Access Compliance Report Public Rights-of-Way (Curb Ramps)

Main Street: RUSTIC_LN Cross Street: KATELLA_AVE Location: NE

ADA ID: RPRK210921112656 Ramp Type: Type 1 - Perpendicular Diagonal Initial Pass/Fail: Pass Overall Compliance: No Severity Score: 4

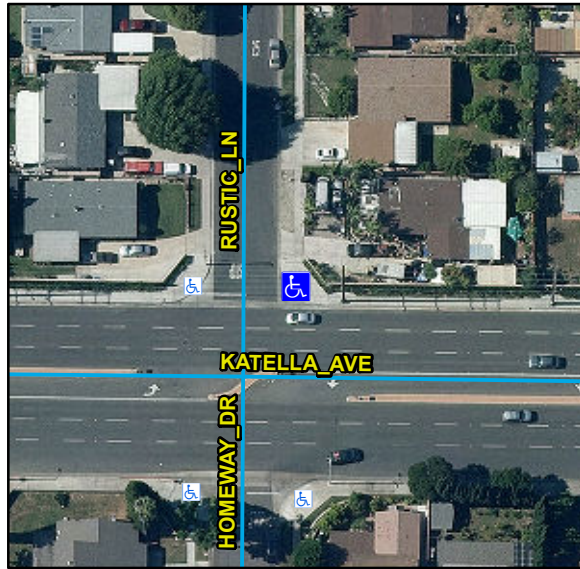
Remove & Replace Landing. Gutter Ponding Observed.

Possible Solutions:
